# UNITED STATES PATENT AND TRADEMARK OFFICE

APPLICATION NO.	FILING DATE	FIRST NAMED INVENTOR	ATTORNEY DOCKET NO.	CONFIRMATION NO.
10/771,627	02/05/2004	Hiroshi Kuzuya	26B-025	9496
23400	7590	02/22/2005	EXAMINER	
POSZ & BETHARDS, PLC 11250 ROGER BACON DRIVE SUITE 10 RESTON, VA 20190			PATEL, VISHAL A	
			ART UNIT	PAPER NUMBER
			3676

## Office Action Summary

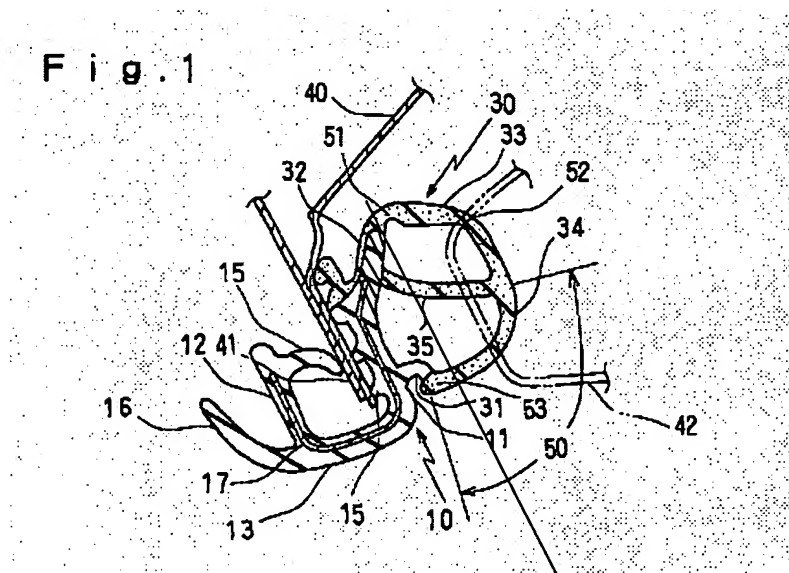
Oda discloses a weather strip comprising a trimming portion having a substantially U-shaped cross section (U-shape that has 17) and attachable to a surrounding part of a door opening of a vehicle (intended use), the trimming portion having an outer side wall portion (outer side wall portion having two lips 15), an inner side wall portion (inner side wall portion having one lip 15), and a connecting portion (13) for connecting the outer and inner side wall portions to each other. The weather strip having a hollow seal portion (hollow portion that contacts 42) connected to the trimming portion at a first connection portion (first connection portion having 31), which is placed substantially at a boundary portion between the connection portion and the outer side wall portion. The hollow seal portion having at a second connection portion (second connection portion by the additional cross-hatching in the attached figure), which is placed closer to a leading end of the outer side wall portion than the first connection portion and adapted to be more flexible than the trimming portion. The weather strip having a projecting portion

(projection portion having the cross-hatching in the attached figure 1) provided in the second connection portion in such a way as to extend from the outer side wall portion of the trimming portion, wherein a thickness (thickness formed by the first cross-hatching line closest to the trimming portion) of the projecting portion along a direction, in which the outer side wall portion extends, is larger than a thickness of a part of the seal portion, which is pressure-contacted to a peripheral portion of the door (the thickness of the projection is larger than the thickness of a part 52 of the seal portion that contacts 42).

The thickness of a base end part (this is also defined by the first cross-hatching line, see attached figure) of the projection portion is equal to or more than twice the thickness of the part of the seal portion.

A thickness of base end part of the projection portion is equal to or more than one-fourth of a length (length from the first cross hatching line to the leading end part that contacts 51) from a leading end part (leading end part that contacts 51) of the outer side wall portion of a boundary portion between the connecting portion and the base end part.

A thickness of the leading end part of the projection is equal to or more than twice the thickness of the part of the seal portion (the leading end part has a thickness that is equal or twice the thickness of the part of the seal portion).

A projection length from a base end part of the projection portion to a leading end part thereof (length of the projection normal from the outer side wall) is larger than the thickness of the part of the seal portion.

The projection length is equal to or more than twice a thickness of the part of the seal portion.

A cross sectional area (area of projecting portion) of the projecting portion is equal to or more than four times an area obtained by square of the thickness of the part of the seal portion.

The entirety of the seal portion is formed in such a way as to be placed closer to a side of the first connection portion than at least the second connection portion in the direction in which the outer side wall portion extends (this is the case since the first connection portion has a length that is smaller than the length of the second projecting portion that attaches the seal portion).
